Proposed Milton Quarry East Extension JART COMMENT SUMMARY TABLE – Natural Environment

JART Comments (December 2022)	Reference	Source of Comment	Applicant Response (Jan 2023)	JART Response
Repoi	rt/Date: Level 1 and 2 Natural Environment Technical Report (NETR) and Environ	mental Impact Asses	ssment (EIA) Dec	ember 2021 Author: Goodban Ecological Consulting	Inc. (GEC)

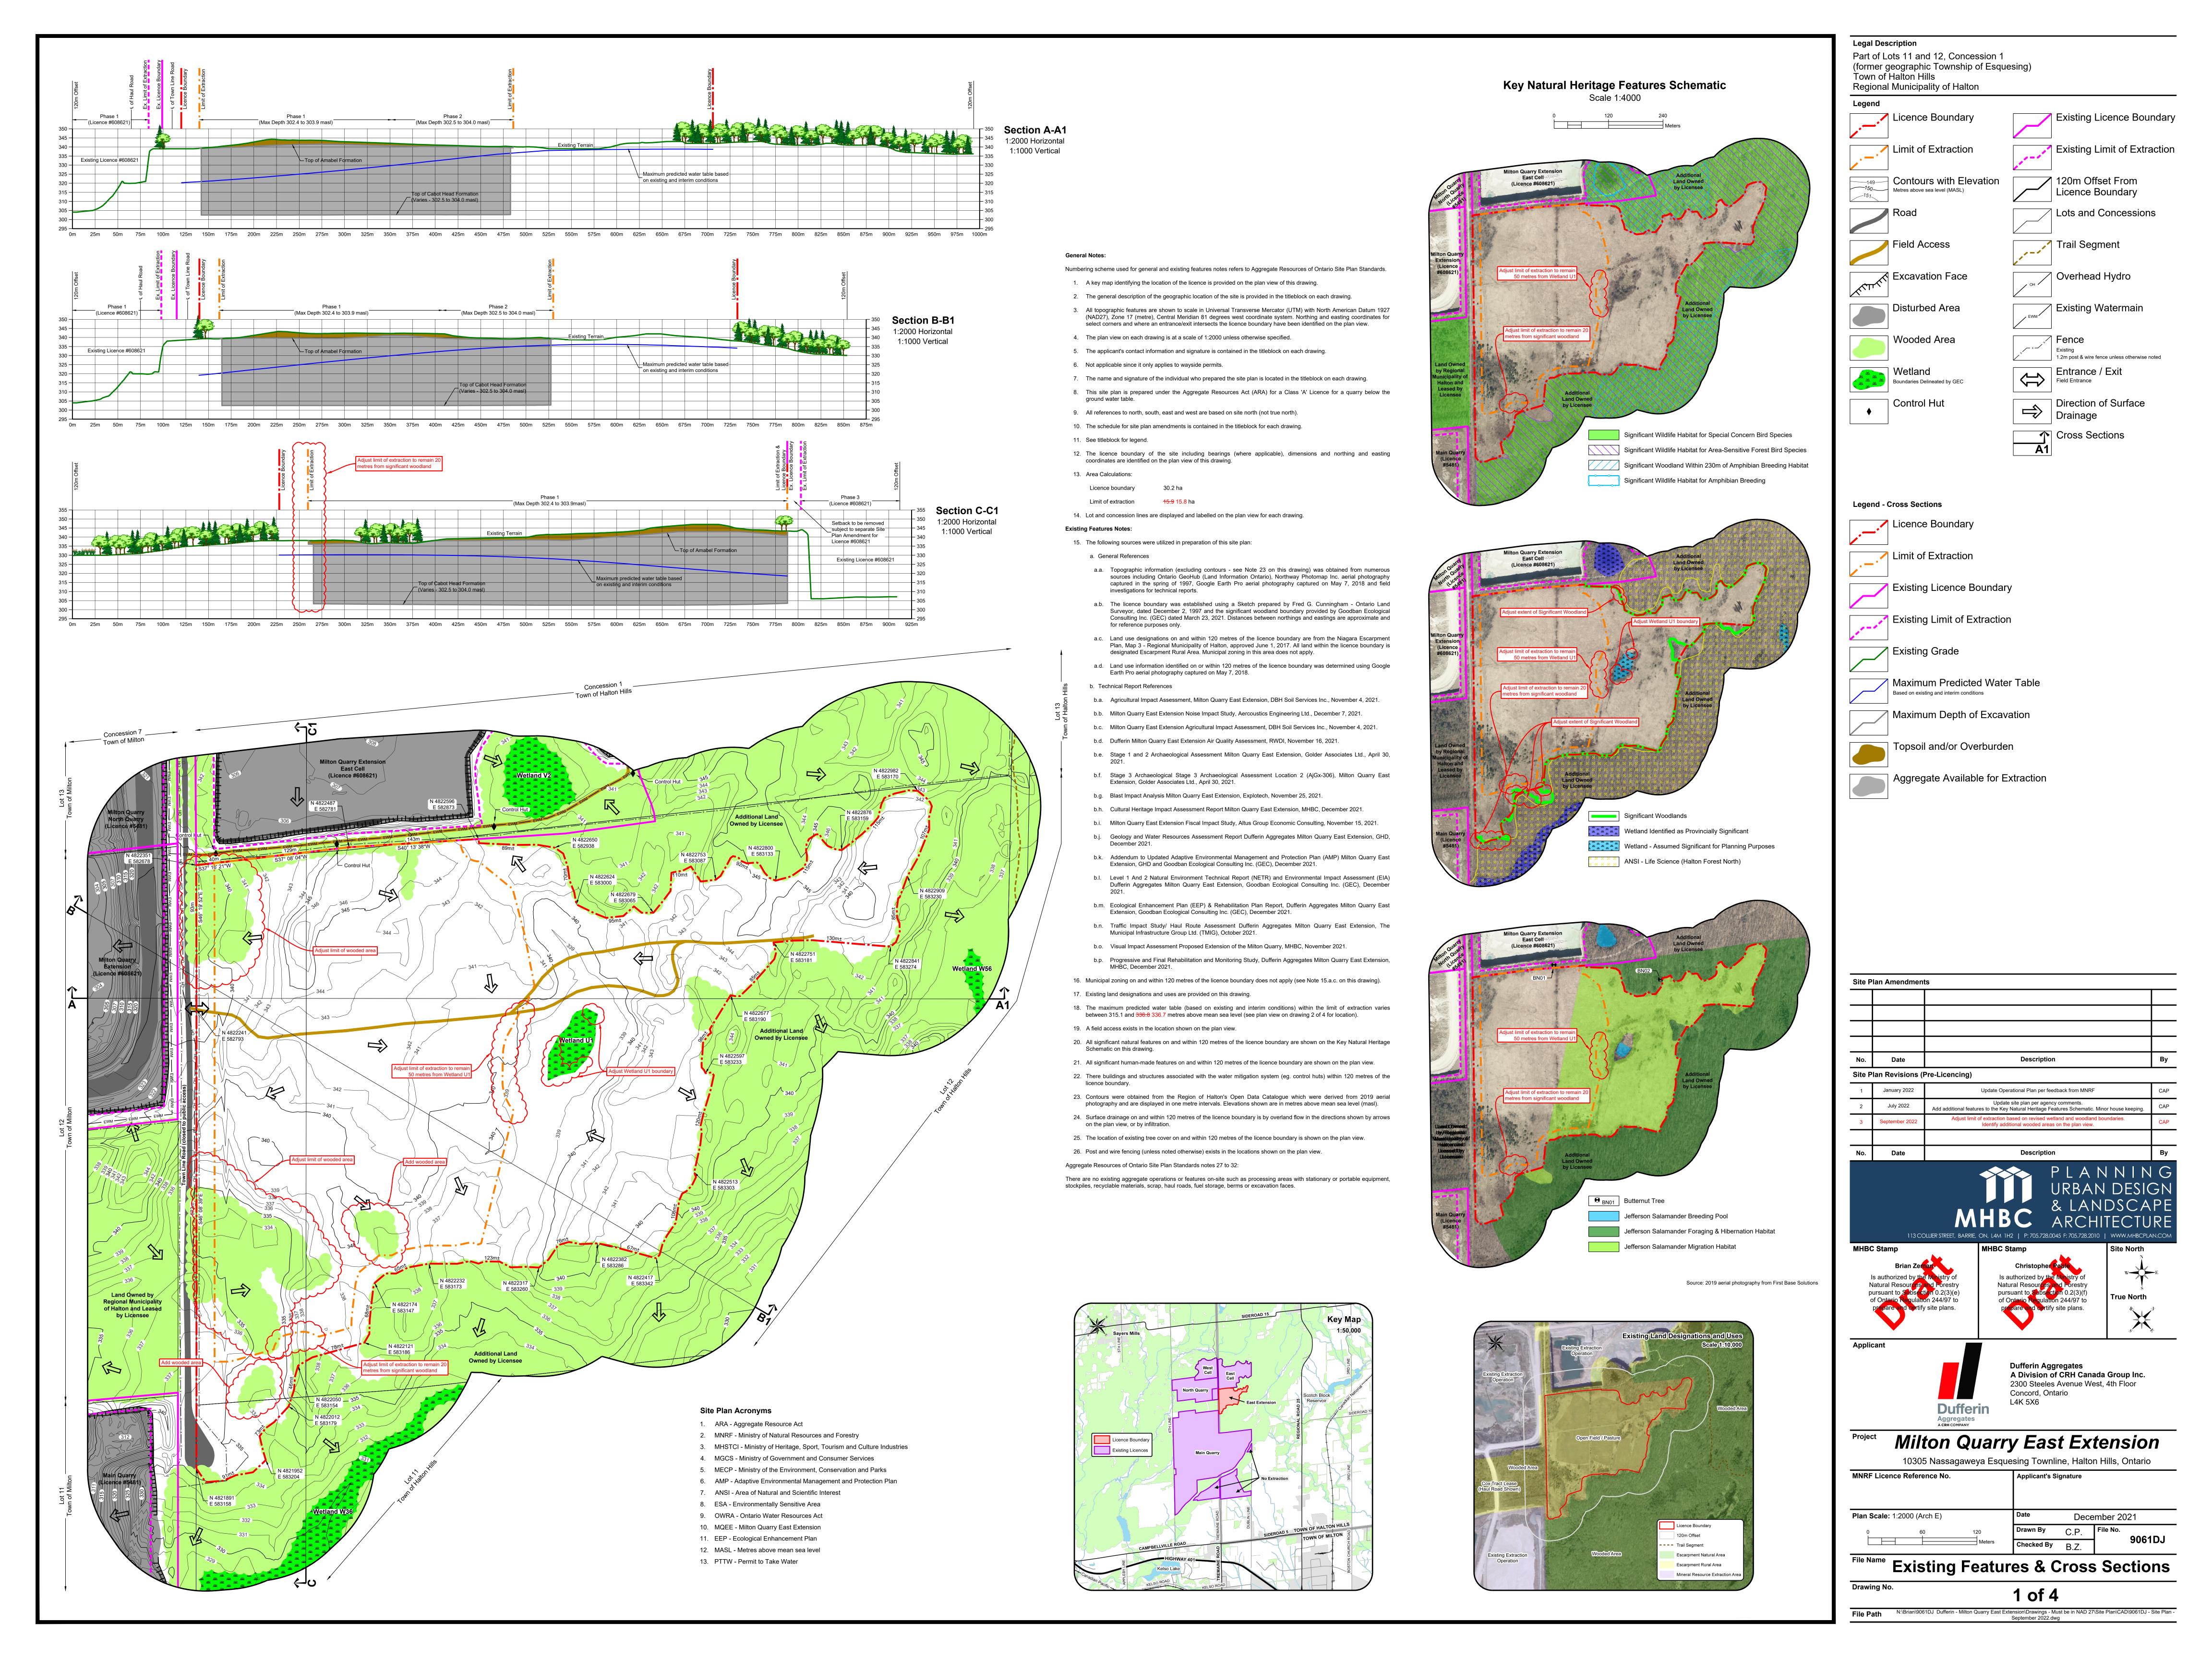
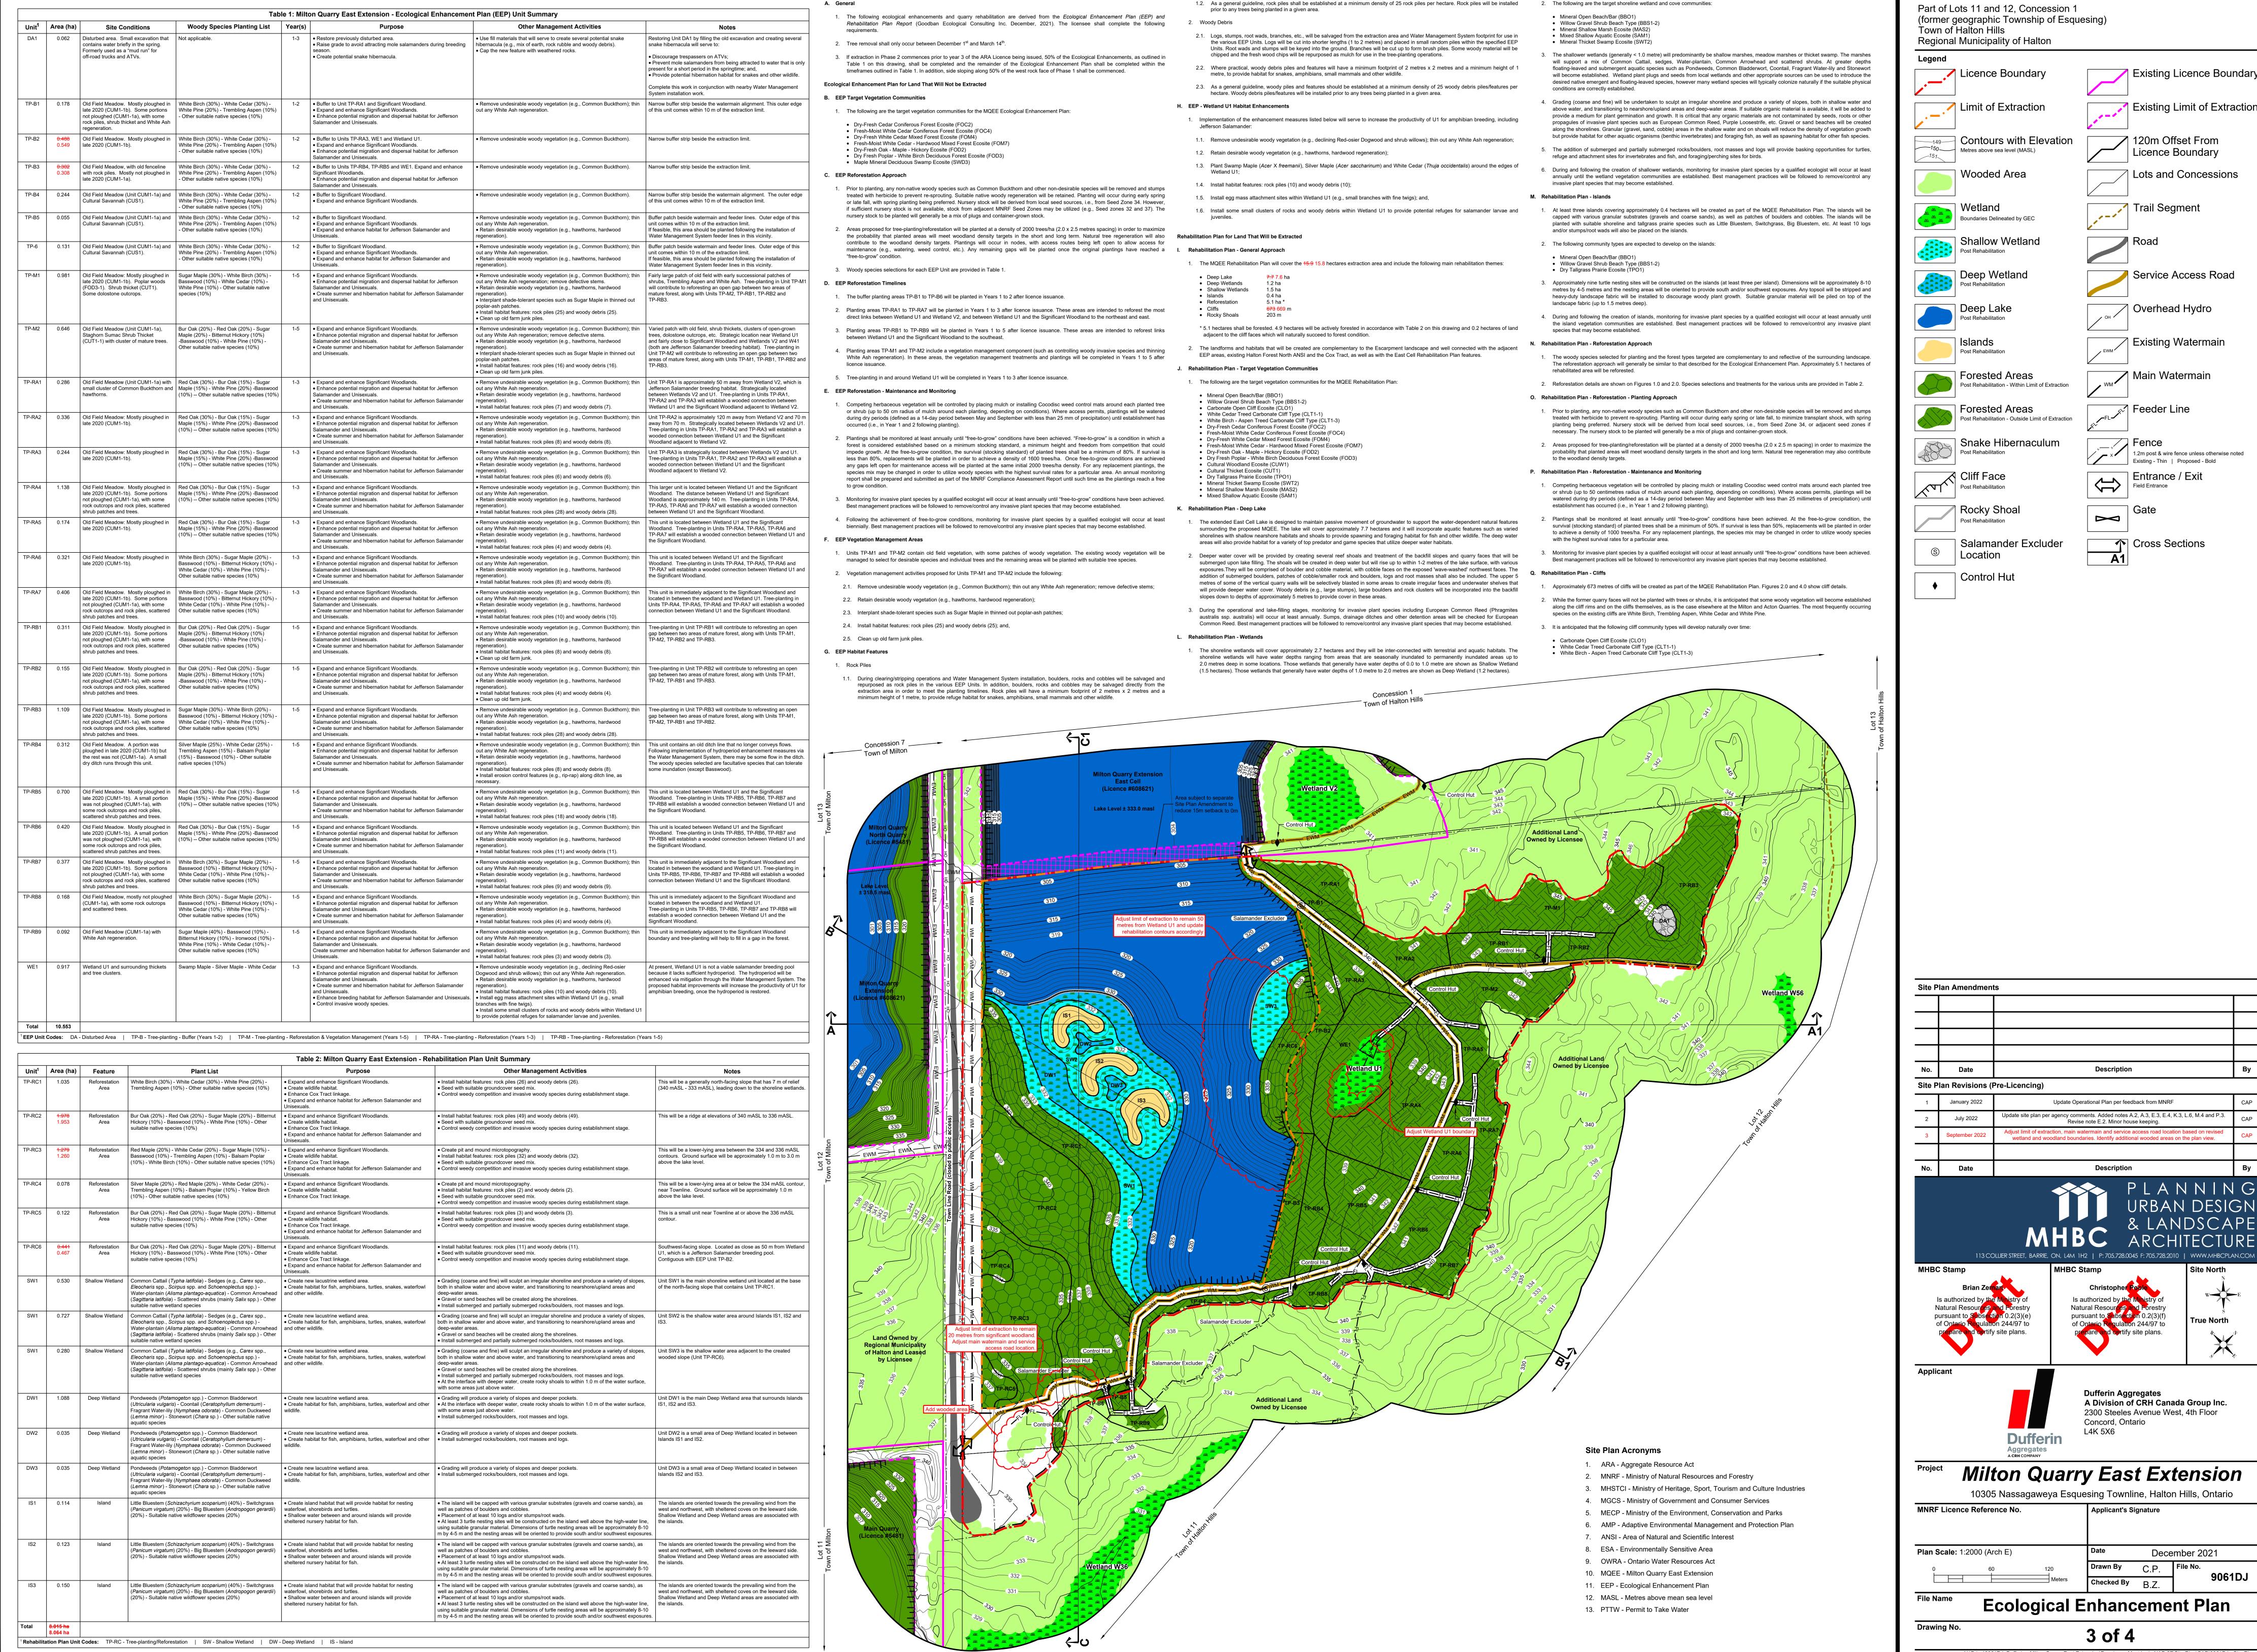
Section 7 provides an analysis of the provincial significance of wetlands in Ecoregion 6E. However, significance of wetlands in Halton Region should also be considered. Analysis of whether wetlands U1 and W56 would be considered significant according to Region of Halton criteria should be provided, in accordance with s.276.5(1) of the		Sarah Mainguy, NSE	Wetland U1 is already identified as a Key Natural Heritage Feature on Schedule 1G (Key Features within the Greenbelt and Regional Natural Heritage Systems) of the Region of Halton Official Plan.	
Regional Official Plan and in consultation with Conservation Halton and MNRF staff. - it is noted that these wetlands are being protected from extraction, with a buffer of 50 m, which is likely more than a Regionally significant wetland would be buffered.			As indicated in Dufferin's July 22, 2022, responses to ARA objection letters from the agencies, Wetland U1 is being treated as Provincially Significant for planning purposes. The ARA Site Plans were updated to reflect this.

See Tab A (Updated NETR & EIA Figures 31, 32, 34 and 35) and Tab B (Updated ARA Site Plans).	
			As indicated on page 75 of the NETR & EIA, Wetland W56 is a small, minor feature with a short, ephemeral

JART Comments (December 2022)	Reference	Source of Comment	Applicant Response (Jan 2023)	JART Response
28.	The boundary delineation for wetland U1 was completed on Wednesday, August 10 th with CH staff, North South Environmental, and Goodban Consulting. Minor modifications to Dufferin's previously staked wetland boundary were completed by moving some of the stakes to better represent the wetland vegetation community and establish CH's regulatory limits. A memo entitled, "MQEE Wetland Boundary Review – August 10, 2022 Site Visit" dated August 29th, 2022, prepared by Goodban Consulting was provided regarding the updated wetland staking exercise and adjusted boundary limit. Upon review of this memo, CH does not have any concerns and agree with the adjusted limit of extraction in response to the adjusted boundary limits for wetland U1. Update all drawings, report figures and the proposed site plan to accurately show the updated boundary limits for wetland U1 and revised limits of extraction.	Level 1 and 2 Natural Environment Technical Report and Environmental Impact Assessment	СН	The ARA Site Plans have been updated to reflect the minor changes made to the Significant Woodland boundary and Wetland U1 boundary resulting from the August 8 and 10, 2022, site visits. Please see Tab B for the updated ARA Site Plans.
